Subject: VIRGIL C. SUMMER NUCLEAR STATION (VCSNS) UNIT 1
DOCKET NO. 50-395
OPERATING LICENSE NO. NPF-12
REPORT OF FULL COMPLIANCE WITH MARCH 12, 2012, COMMISSION
ORDER MODIFYING LICENSES WITH REGARD TO RELIABLE SPENT FUEL
POOL INSTRUMENTATION (ORDER EA-12-051) AND RESPONSES TO
REQUESTS FOR ADDITIONAL INFORMATION

VIRGIL C. SUMMER NUCLEAR STATION (VCSNS) UNIT 1

ENCLOSURE 2

RESPONSE TO INTERIM STAFF EVALUATION AND REQUEST FOR ADDITIONAL INFORMATION REGARDING THE OVERALL INTEGRATED PLAN FOR IMPLEMENTATION OF ORDER EA-12-051, *RELIABLE SPENT FUEL POOL INSTRUMENTATION*

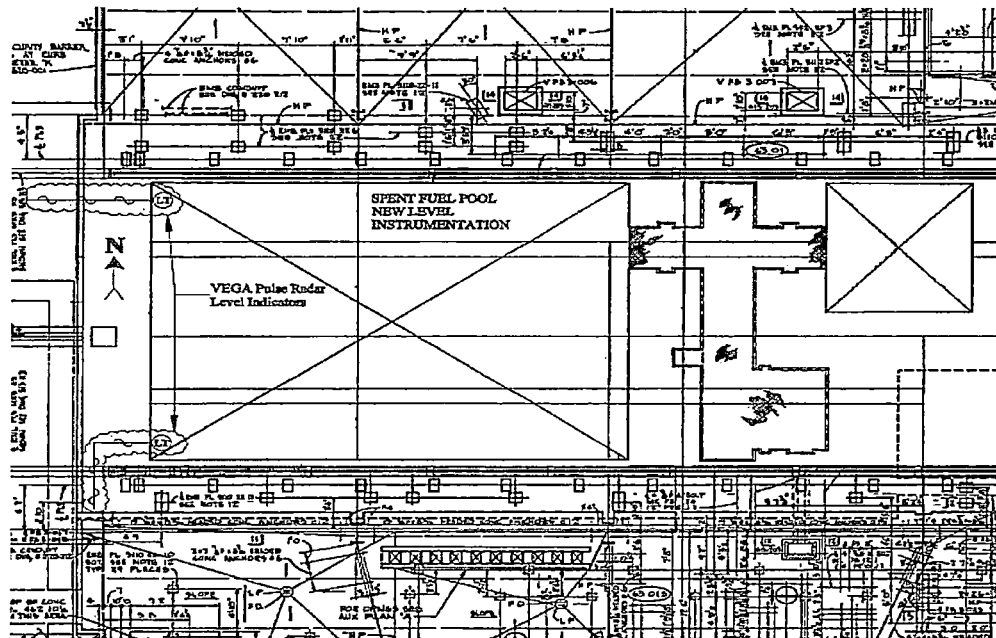
Please provide an evaluation verifying the seismic testing of the horn and waveguide assembly and the electronics units, and the analysis of the combined maximum seismic and hydrodynamic forces on the cantilevered portion of the assembly exposed to the potential sloshing effects, demonstrate that the SFP instrument design configuration will be maintained during and following the maximum seismic ground motion considered in the design of the SFP structure.

The potential SFP sloshing effects due to a postulated seismic event have been evaluated for the primary and backup channels in VCSNS design calculation DC00080-004, *Spent Fuel Pool Sloshing Evaluation for SFPLI Equipment*. The maximum seismic induced wave height in the SFP as well as maximum hydrodynamic (convective mode) pressures which are potentially imparted upon FLEX SFPLI installed by Engineering Change Request (ECR) 51001 were calculated. The maximum calculated wave height of 2.56 feet and associated hydrodynamic pressure of 1.1 psi is presented as input to design and calculation of the applicable FLEX SFPLI components installed atop the SFP walls in the FHB.

The Required Response Spectra (RRS) used for seismic testing of the SFP primary and backup level instrumentation and the electronics units envelop the VCSNS design basis seismic spectra for the locations where the equipment will be installed.

The remote transmitter mounting support is qualified by a generic calculation using a simple C-channel steel section that is welded centrally on a steel base plate on the outside west wall of the FHB (backup) and the east wall of the north AB stairwell (primary). The generic sensor mounting support was designed for generic enveloping seismic accelerations of 10g (horizontal) and 6.67g (vertical), which envelope the site seismic response spectra at the applicable locations and frequencies. The calculation further assumed an enveloping sensor cantilevered length.

The horn mounting support is qualified similarly to the remote transmitter support. It is qualified by a site specific calculation using a simple C-channel steel section welded on a base plate on the concrete operating deck floor in the spent fuel pool area. The generic design of the horn mounting support conservatively uses generic seismic accelerations of 10g (horizontal) and 6.67g (vertical). A visual representation of the pool edge mounting configuration for the radar horn is shown in Figures 1 and 2 of the VCSNS response to NRC's request for additional information regarding the SFPLI OIP (i.e., ADAMS Accession No. ML15062A008). The submittal also provided the mounting configuration. The layout is depicted in the following SFPLI location drawing.
